March 2, 1988

SUBJECT: PUBLIC MEETING BETWEEN TU ELECTRIC AND CASE
AND MARK WALSH ON FEBRUARY 18, 1988

<u>DATES & TIME</u>	<u>LOCATION</u>	<u>PURPOSE</u>
Thursday, February 18, 1988 8:30 a.m.	Sheraton Hotel Houston/Austin Room 400 N. Olive Street Dallas, Texas	Discuss Corrective Action Program (Cable Tray Hangers and Conduit and Conduit Supports)
Friday, February 19, 1988 8:00 a.m.	Comanche Peak Steam Electric Station (CPSES) Site (Visitors Center)	CPSES Plant Tour

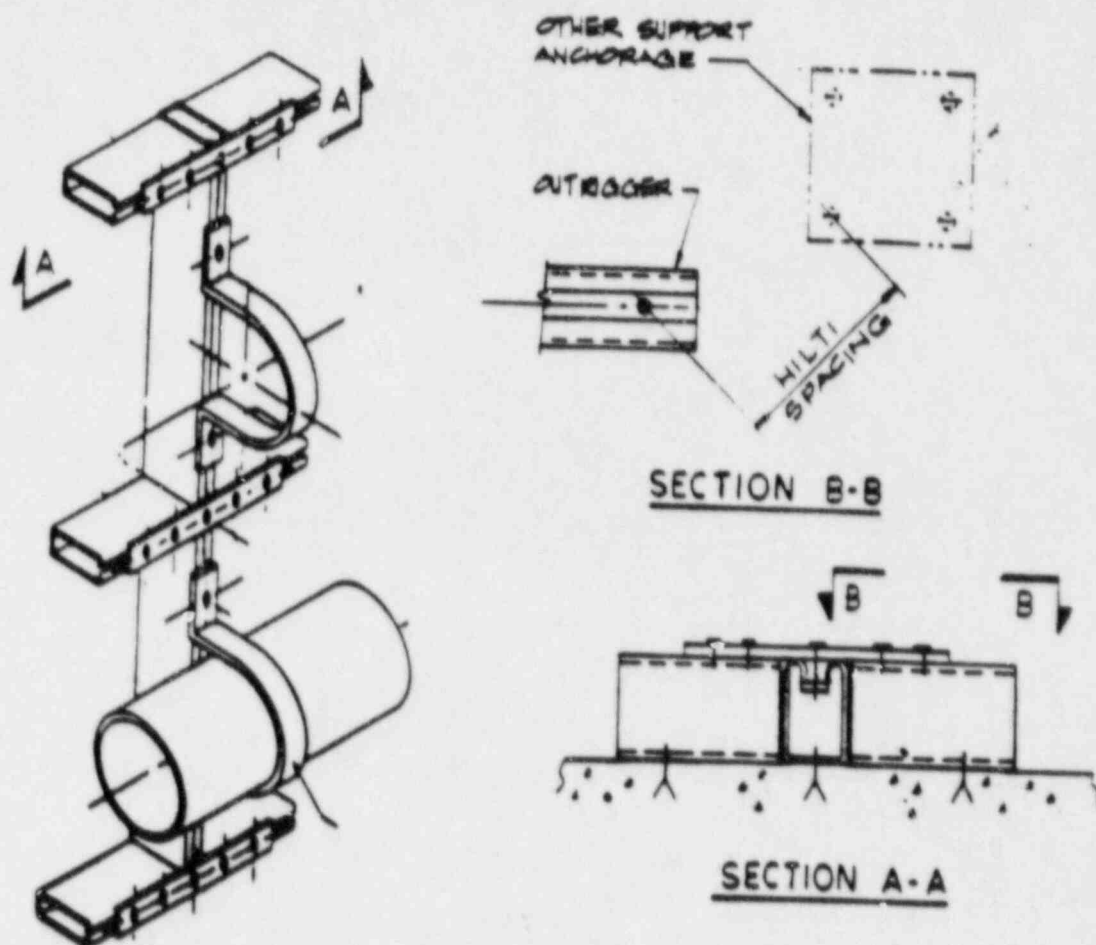
- C. OUTRIGGER HILTI-KWIK BOLTS FOR THE ORIGINAL CA-2A SUPPORTS WERE ASSUMED NOT TO TAKE ANY LOAD. HOWEVER, SOME LOAD MAY BE IMPOSED DUE TO CONDUIT LOADS AND PRESTRESSING OF THE SUPPORT. THE OUTRIGGER HILTI-KWIK BOLTS MAY NOT BE ADEQUATE IN RESISTING THESE LOADS SINCE THE DESIGN DRAWING WAIVES SEPARATION VIOLATIONS BETWEEN HILTI-KWIK BOLTS IN THE OUTRIGGERS AND ANY OTHER BOLTS.

CA-2A TYPE UNISTRUT SUPPORT WAS TESTED (CCL REPORT NO. A-678-85) WITHOUT HILTI-KWIK BOLTS ON THE OUTRIGGERS. THEREFORE, THESE HILTI-KWIK BOLTS ARE NOT REQUIRED TO ACHIEVE THE SUPPORT CAPACITY. VALIDATION OF OTHER SUPPORTS WHICH DO NOT COMPLY WITH SEPARATION CRITERIA WILL BE PERFORMED AS PART OF THE POST CONSTRUCTION HARDWARE VALIDATION PROGRAM.

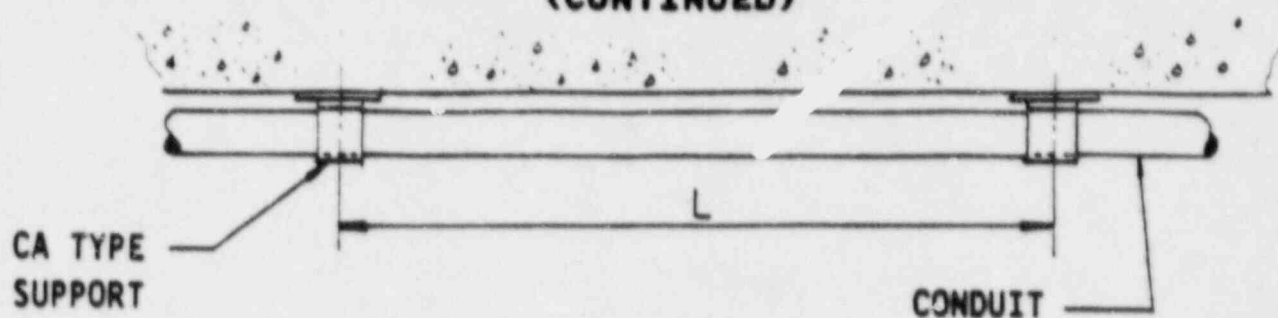
CA TYPE SUPPORT DRAWINGS ALLOWED SUBSTITUTION OF SMALLER CONDUITS FOR LARGER CONDUITS. SINCE CA TYPE SUPPORTS WERE DESIGNED USING ZPA VALUES FOR LARGE SIZE CONDUIT, AND SMALL CONDUIT SIZES WERE DESIGNED FOR PEAK ACCELERATIONS, THIS SUBSTITUTION MAY RESULT IN LARGER LOADS THAN REFLECTED IN THE ORIGINAL CALCULATIONS.

DESIGN VALIDATION PROCEDURE SAG.CP10 SPECIFIES THAT CA TYPE SUPPORTS SHALL BE DESIGN VALIDATED BASED ON DESIGN ACCELERATIONS WHICH BOUND ALL CONDUIT SIZES.

TYPICAL FLEXIBLE CONDUIT CONNECTED TO LADDER/SOLID BOTTOM TRAY
DRAWING NO. 2323-S-0910, SHEET CSD-16.

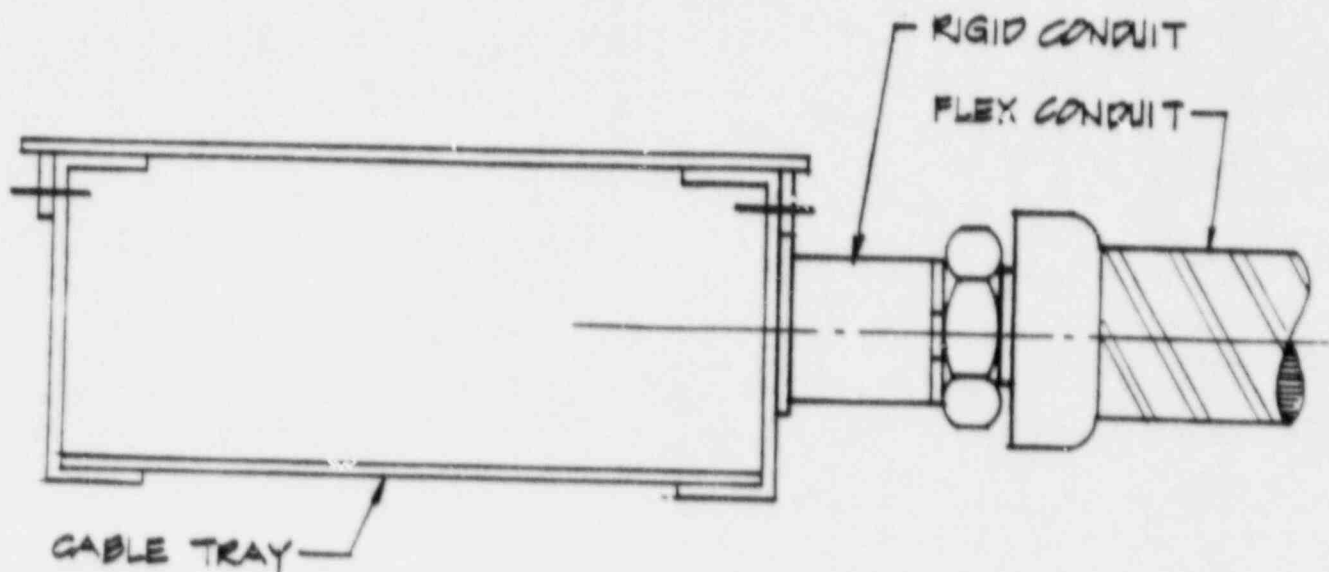
SH. CSD-16 OF DRAWING NO. 2323-S-0910 PACKAGE ALLOWS CONDUIT TO BE ATTACHED TO CABLE TRAY. IN THE ORIGINAL DESIGN, CABLE TRAY MAY HAVE BEEN DESIGNED WITHOUT ADDITIONAL CONDUIT LOAD. IN ADDITION, ZPA SHOULD NOT BE USED TO COMPUTE CONDUIT LOAD SINCE CABLE TRAY MAY BE FLEXIBLE.

THE DESIGN VALIDATION PROCEDURE SAG.CP10 SPECIFIES THAT THE CONDUIT AND ITS CONNECTION TO THE CABLE TRAY ARE TO BE DESIGN VALIDATED FOR 1.5 TIMES RESPONSE SPECTRA PEAK ACCELERATION. DEADWEIGHT FOR BOTH THE RIGID AND MAXIMUM FLEXIBLE CONDUIT ALLOWED IN SH. CSD-16 OF DRAWING NO. 2323-S-0910 PACKAGE WERE INCLUDED IN THE DESIGN VALIDATION OF THE CONDUIT. IN ACCORDANCE WITH CABLE TRAY WALKDOWN PROCEDURE CPE-EB-FVM-048, SUCH CONFIGURATIONS ARE BEING IDENTIFIED AND EVALUATED IN THE CABLE TRAY POST CONSTRUCTION HARDWARE VALIDATION PROGRAM (SEE EXTERNAL SOURCE ISSUE NO. 32 FOR CABLE TRAY AND CABLE TRAY HANGERS).

SYSTEMS CONCEPT
(CONTINUED)

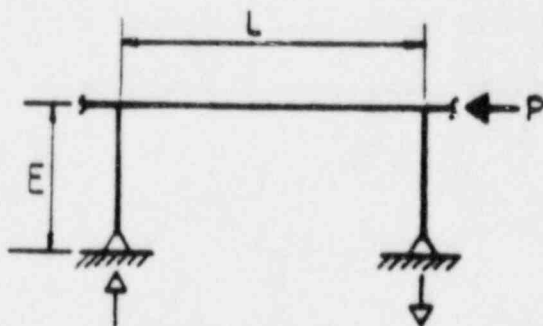
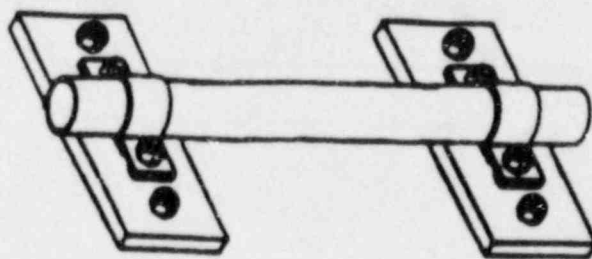
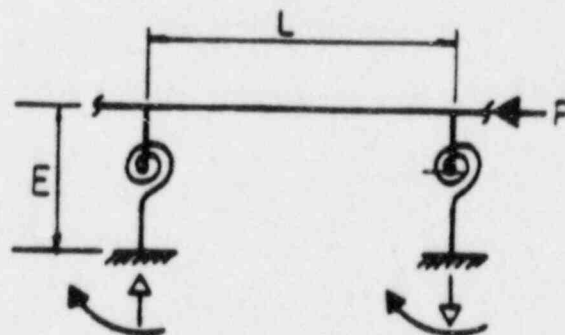
IN THE ORIGINAL DESIGN OF TWO-BOLT CONCRETE SURFACE MOUNTED SUPPORTS, THE ACCEPTABILITY OF THE SUPPORT WAS ESTABLISHED BY ASSUMING THAT THE MOMENT GENERATED BY THE ECCENTRICALLY APPLIED LONGITUDINAL LOAD WOULD NOT BE RESISTED BY THE SUPPORT. THIS MOMENT WOULD BE BALANCED BY A LOAD COUPLE CONSISTING OF FORCES GENERATED AT THE SUPPORT OF INTEREST AND THE NEXT SUPPORT. POSSIBLE DIFFERENCES IN SUPPORT AND CONDUIT STIFFNESSES WERE NOT CONSIDERED. APPLICABILITY OF THESE CALCULATIONS TO OTHER SUPPORTS WAS NOT DEMONSTRATED.

DESIGN VALIDATION PROCEDURES SAG.CP10 AND SAG.CP29 REQUIRE THAT LOAD ECCENTRICITY EFFECTS BE INCLUDED IN THE DESIGN VALIDATION OF ALL CONDUIT SUPPORTS.

TWO-BOLT CONCRETE SURFACE MOUNTED SUPPORTS HAVE BEEN DESIGN VALIDATED BY CONSIDERING THAT THE MOMENTS INDUCED BY ECCENTRICALLY APPLIED LONGITUDINAL LOADS ARE SHARED BETWEEN THE SUPPORT AND THE CONDUIT IN ACCORDANCE WITH THE STIFFNESS OF THE SYSTEM COMPONENTS.
